Detailed Site Plan Alternative Compliance Communicare Health

DET-2023-005
ACL-2025-001

SUBJECT: Detailed Site Plan DET-2023-005
Alternative Compliance ACL-2025-001
Communicare Health

Figure 1: South Building Elevation Facing Marlboro Pike

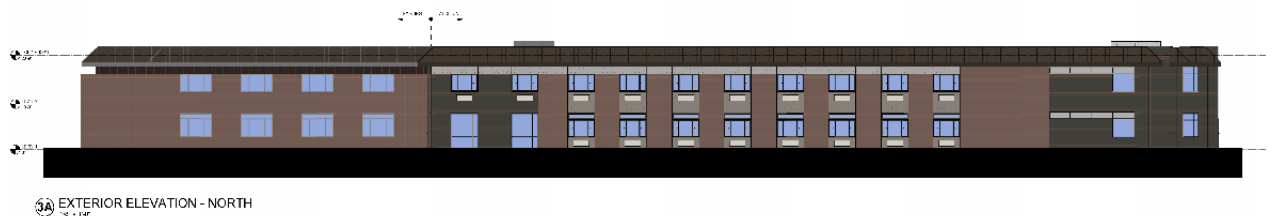
The architectural elevations submitted with this DET show a variety of building materials used for the proposed addition, including bricks, brick veneer, and fiber cement panels. The materials are shown in a variety of colors, such as bark, rich espresso, and timber bark. The existing building façades feature dark brown brick, and the existing roof is mansard roof with brown asphalt shingles. The proposed addition maintains the existing mansard roof shape. The standing seam metal roof will be used uniformly throughout both the existing building and new addition, enhancing visual cohesion and durability. The proposed façade and roof materials ensure a seamless and cohesive transition between the existing building and proposed addition. Upon reviewing the black-and-white elevation, staff find an inconsistency in the roof materials labeling. A condition is included herein to revise the black-and-white architectural elevation with clear labels, ensuring consistency in roof material labeling.

Regarding façade articulation, the front façade unchanged as it is an existing condition. The side and rear façade, each exceeding 60 feet in length, incorporates offset alternatives to meet the requirement of this section. Those techniques include changes in façade color and materials that follow the same dimensional standards as the offset requirements, and roofline change in height of a parapet at proposed entrances locations.

- k. Revise the black-and-white architectural elevation with clear labels, ensuring consistency in roof material labeling.
- l. Revise the photometric plan as follows:
